SIB 61 23 20

2021-04-02

## RECALL 20V-601: HIGH-VOLTAGE BATTERY RECALL

This Service Information Bulletin (Revision 8) replaces SI B61 23 20 **dated December 2020**.

**SP44 HV Battery (G05) modules-**

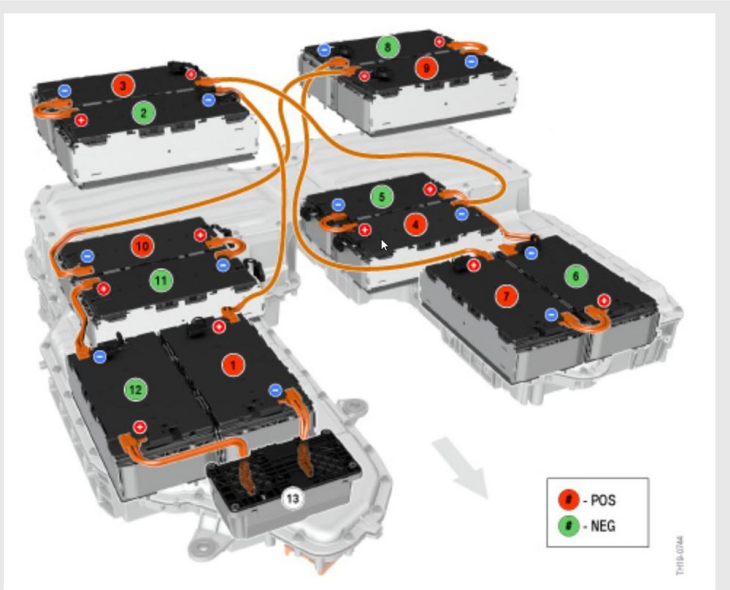
**Modules are designed as Positive and Negative modules (with different orientation and part numbers). When replacing modules, verify in EPC the correct part (POS/NEG) and reinstall according to their original position. See below.**

Use EPC diagram to verify the correct module part number (01/02) for NEG or POS modules.

Use the illustration on the right to match the part# with the correct module installation location.

- Module 12 is **NEG (01)**
- Module 1 is **POS (02)**
- Module 11 is **NEG (01)**
- Module 10 is **POS (02)**
- Module 2 is **NEG (01)**
- Module 3 is **POS (02)**
- Module 8 is **NEG (01)**
- Module 9 in **POS (02)**
- Module 5 is **NEG (01)**
- Module 4 is **POS (02)**
- Module 6 is **NEG (01)**
- Module 7 in **POS (02)**

**SP41 HV Battery (G01/G20/G20/G12) modules-**

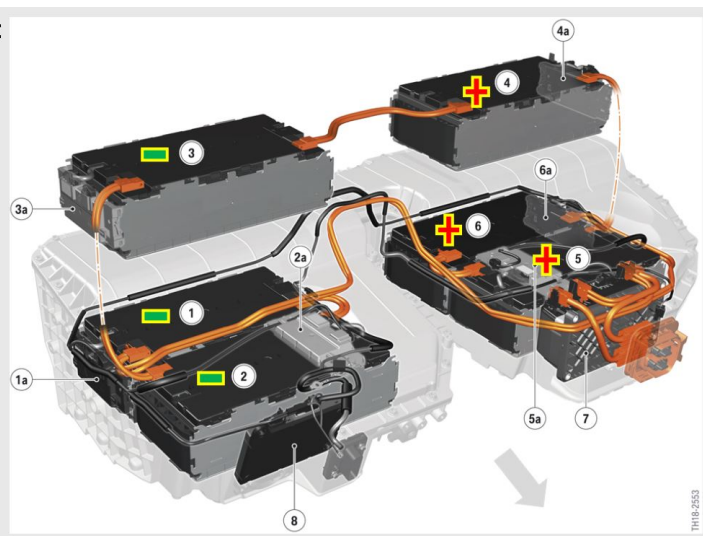
Use EPC diagram to verify the correct module part number (01/02) for NEG or POS modules.

Use the illustration on the right to match the part# with the correct module installation location.

- Module 1 is **NEG (01)**
- Module 2 is **NEG (01)**
- Module 3 is **NEG (01)**
- Module 4 is **POS (02)**
- Module 5 is **POS (02)**
- Module 6 is **POS (02)**
